**LOS ANGELES REGION
UNIFORM CODE PROGRAM**

**RECOMMENDED TECHNICAL
AMENDMENTS TO THE
2010 CALIFORNIA BUILDING CODE,
2010 CALIFORNIA RESIDENTIAL CODE,
AND
2010 CALIFORNIA GREEN BUILDING
STANDARDS CODE**

Final Draft: August 26, 2010

**ICC LOS ANGELES BASIN CHAPTER'S
STRUCTURAL CODE COMMITTEE,
CRC CODE COMMITTEE, AND
GREEN BUILDING STANDARDS CODE COMMITTEE.**

TABLE 2306.2.1(3)–continued
ALLOWABLE SHEAR (POUNDS PER FOOT) FOR WOOD STRUCTURAL
PANEL DIAPHRAGMS WITH FRAMING OF DOUGLAS FIR-LARCH,
OR SOUTHERN PINE^a FOR SEISMIC LOADING^f
FOR STRUCTURES ASSIGNED TO SEISMIC DESIGN CATEGORY D, E OR F

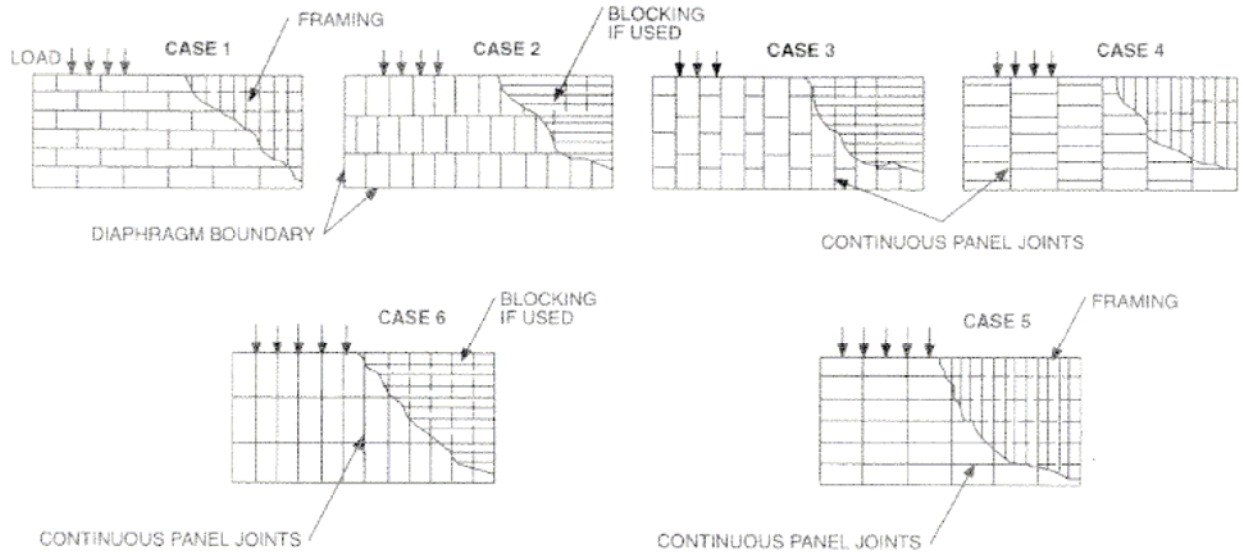
2010 LARUCP 23-04. Tables 2306.2.1(3) and 2306.2.1(4) are added to Chapter 23 of the 2010 Edition of the California Building Code and Section 2306.2.1 of the 2010 Edition of the California Building Code is amended to read as follows:

FIGURE R403.1.5
STEPPED FOOTING

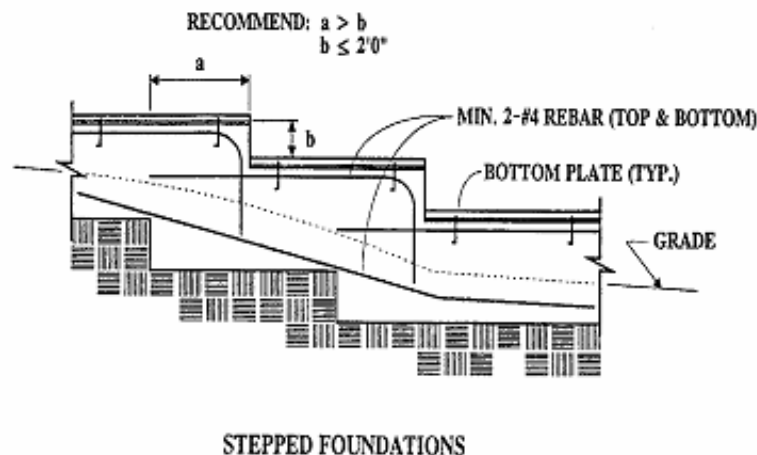
For structures located in Seismic Design Categories D₀, D₁ or D₂, stepped footings shall be reinforced with four 1/2-inch diameter (12.7 mm) deformed reinforcing bars. Two bars shall be place at the top and bottom of the footings as shown in Figure R403.1.5.

**FIGURE R602.10.3.2
ALTERNATE BRACED WALL PANEL**

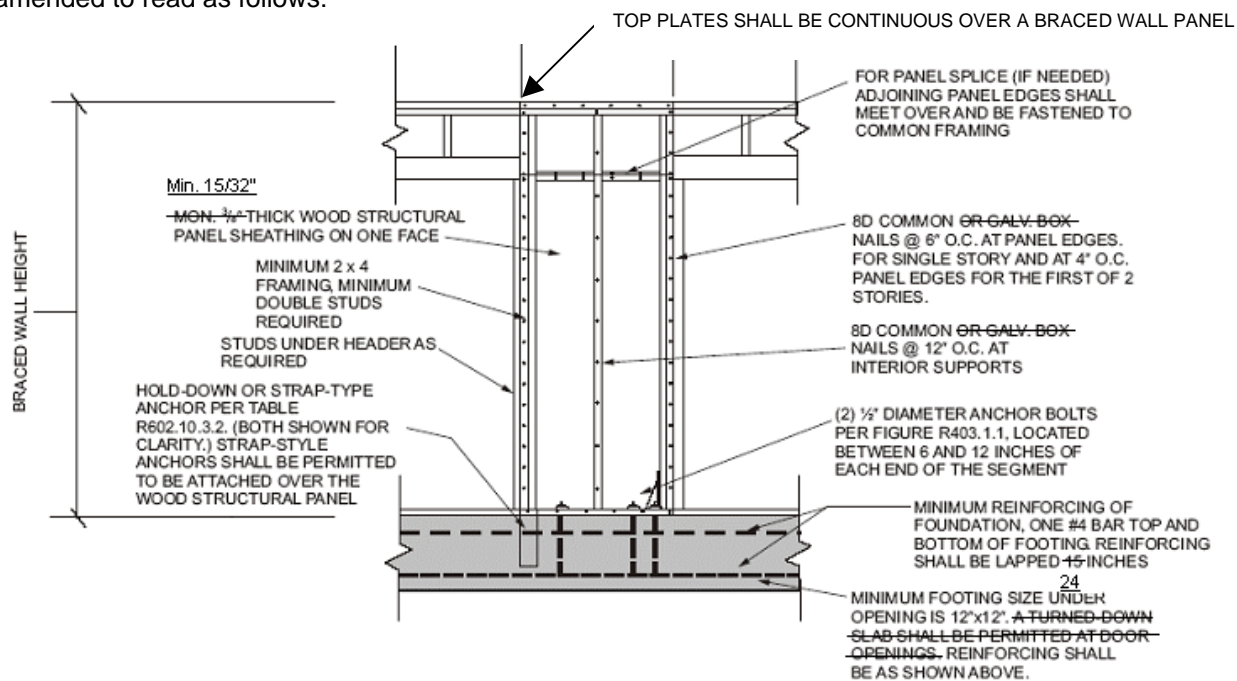
2010 LARUCP R6-05. Figure R602.10.3.2 of the 2010 Edition of the California Residential Code is amended to read as follows:

FIGURE R602.10.3.3

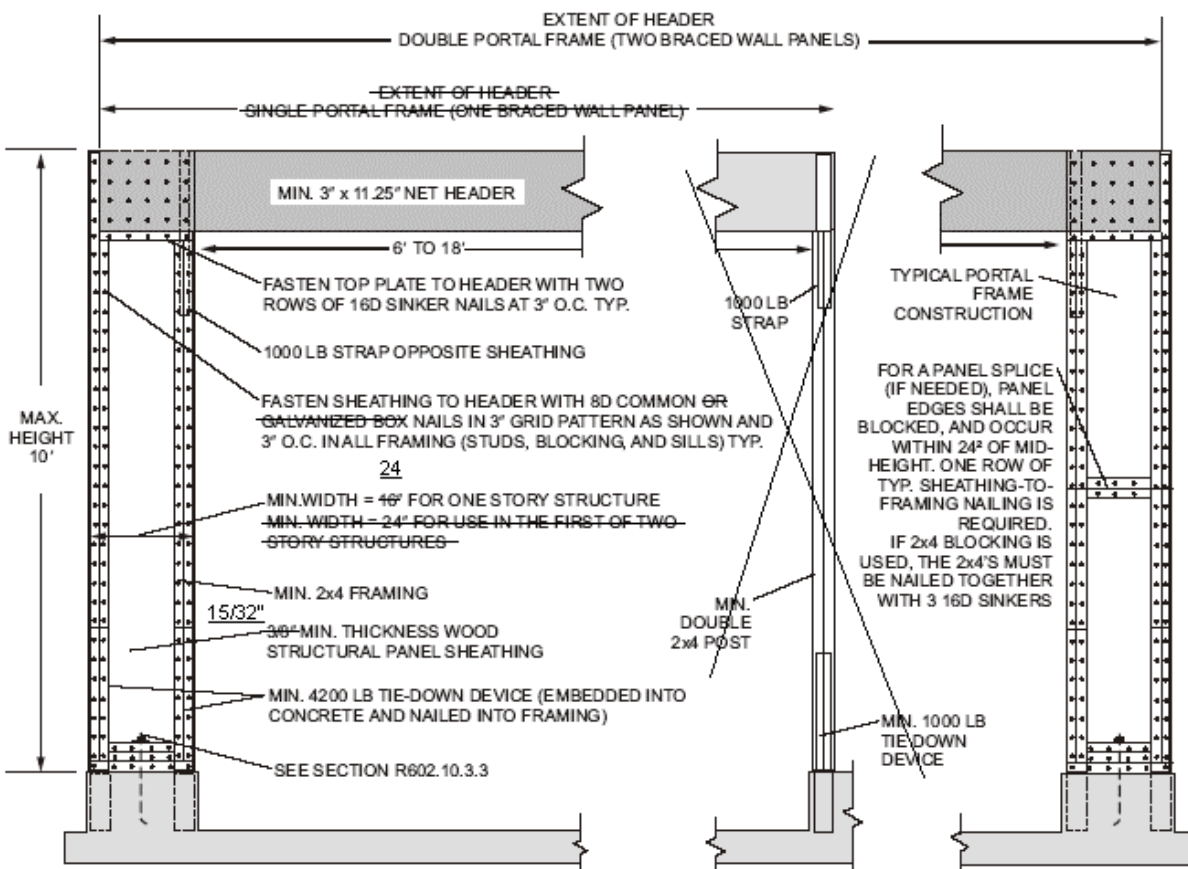
2010 LARUCP R6-06. Figure R602.10.3.3 of the 2010 Edition of the California Residential Code is amended to read as follows:
